Work Order ID 108691

Item Name: Crosstube Turning Detail

DART AEROSPACE LTD	Work Order:	108691
Description: Crosstube Assembly	Part Number:	D206-667-243
Inspection Dwg: D206-667-243 Rev: C		Page 1 of 2

DRAWING NO. D206-667-243	TITLE CROSSTUBE ASS'Y (206L HIGH AFT)	REV. C	DART AEROSPACE LTD ENGINEERING ORDER		D.E.O. NO. D206-667-243-C-1	SHEET NO. - SHEET 1 OF 1	SCALE NTS
DRAWN <i>qp</i>	CHECKED <i>ADS</i>	MFG. APPR. <i>RB</i>	APPROVED <i>MP</i>		DE APPR. <i>#</i>		
DATE 11.07.15	DATE 11.07.20	DATE 11.07.21	DATE 11/07/21		DATE 11.07.21

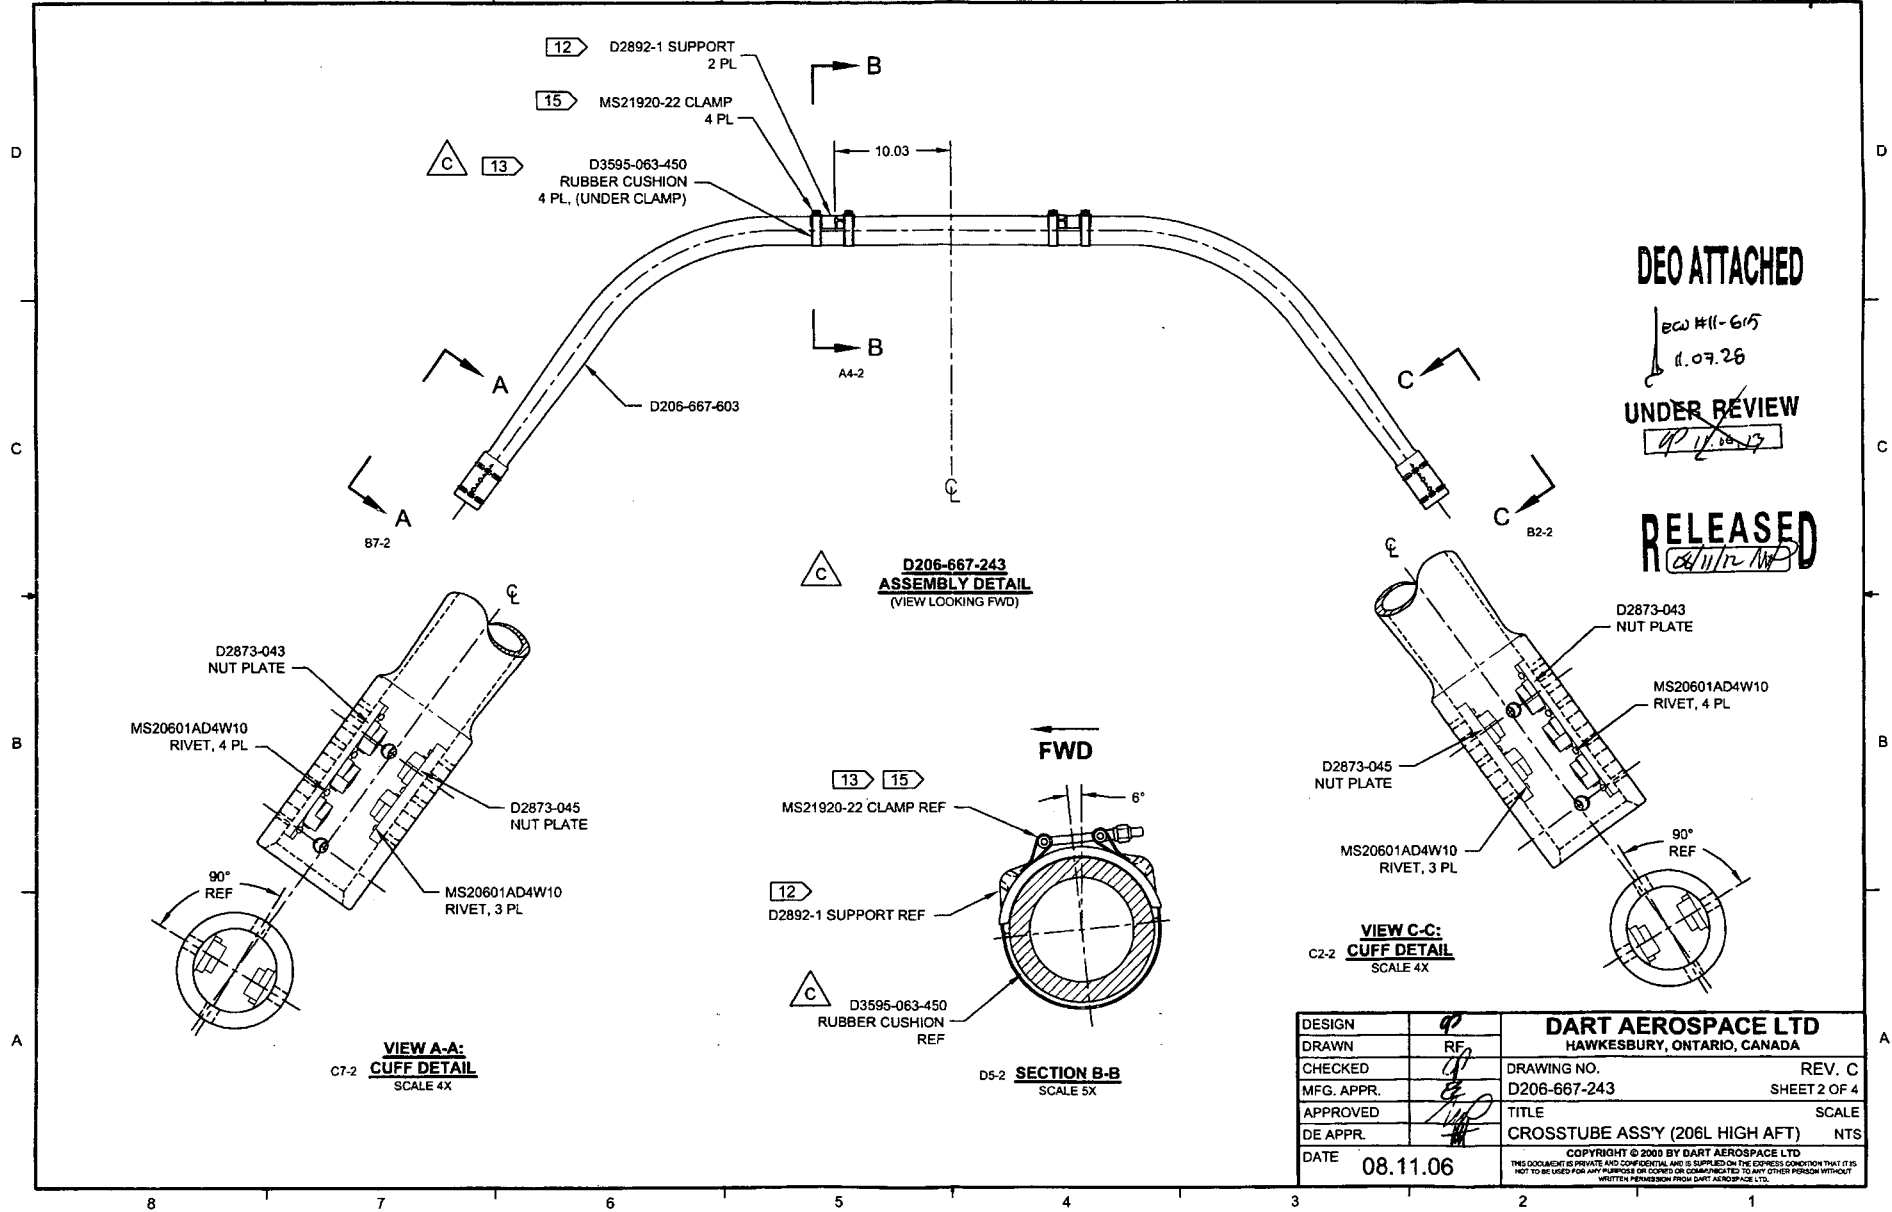
PURPOSE:

REPLACE MAGNOBOND WITH PROSEAL.

NOTE 12 & 15, SHEET 1 IS AMENDED AS FOLLOWS:

Item	Qty -243	Part Number	Description
9	A/R	PROSEAL 890 B-2	SEALANT, AMS-S-8802 CLASS B-2

- 12) TO INSTALL D2892-1 SUPPORT: ABRABE MATING SURFACE OF SUPPORT AND CROSSTUBE WITH 180-GRIT SANDPAPER AND REMOVE RESIDUE WITH MEK (OR EQUIVALENT). APPLY A 0.04" TO 0.07" THICK LAYER OF PROSEAL 890 CLASS B-2 (OR AMS-S-8802 CLASS B-2) SEALANT TO MATING SURFACE OF SUPPORT.
- 15) TORQUE CLAMPS 80 TO 100 IN-LB. ENSURE AT LEAST 1.5 THREADS SHOWING IN SAFETY AND THAT NUT HAS NOT BOTTOMED-OUT AFTER TORQUING. **PRIOR TO PACKAGING, RE-CHECK TORQUE ON CLAMPS AFTER PROSEAL 890 SEALANT HAS CURED FOR 72 HOURS.**
